APPLICATION FOR A CERTIFICATE OF APPROPRIATENESS – STAFF REPORT

005-18-CA 807 W SOUTH STREET

<u>Nature of Project</u>: Remove rear deck; construct rear addition; construct rear porch and patio <u>Amendments</u>: Additional documentation was received with changes to the design and materials.

005-18-CA Amendments Feb 22, 2018 Meeting

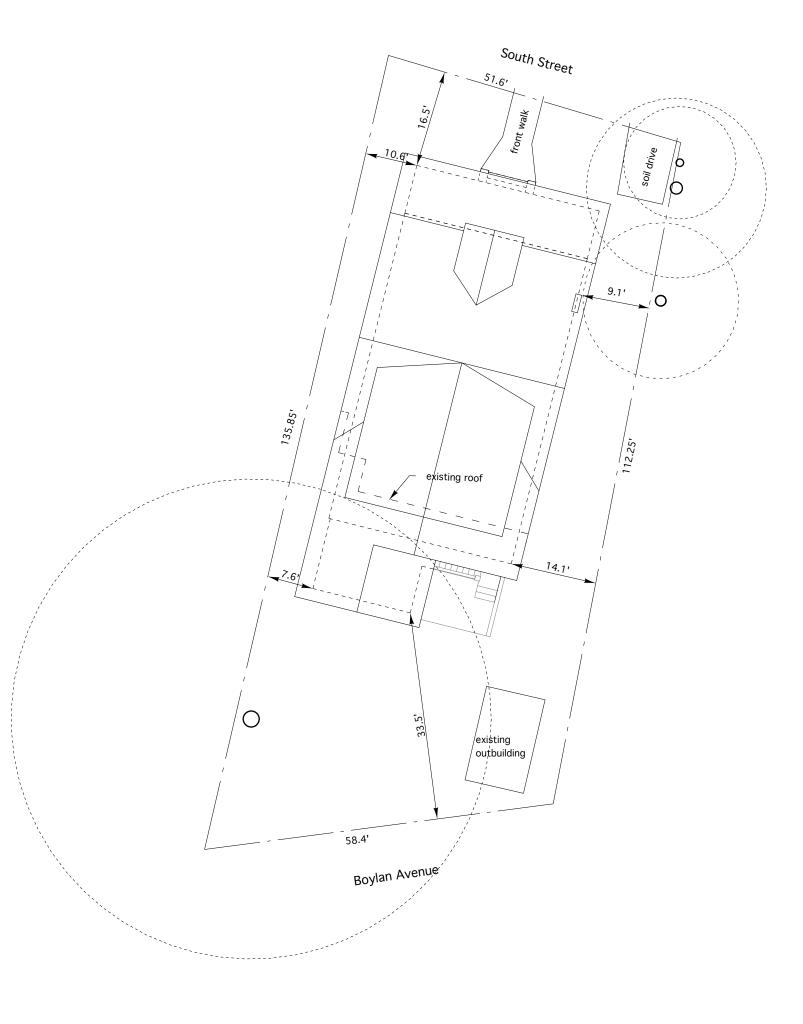
- 3* Section drawings of the porch and railings were not provided.
- 4* A tree protection plan was not provided; however, the critical root zones of four trees were identified on the site plan. Nor were staging areas for construction materials identified.

- 2* A tree protection plan was not provided; however, the critical root zones of four trees were identified on the site plan. Nor were staging areas for construction materials identified.

- a. Tree protection plan prepared by an arborist certified by the International Society
 of Arboriculture or a Licensed Landscape Architect that addresses the critical
 root zones and provides staging areas for construction materials;
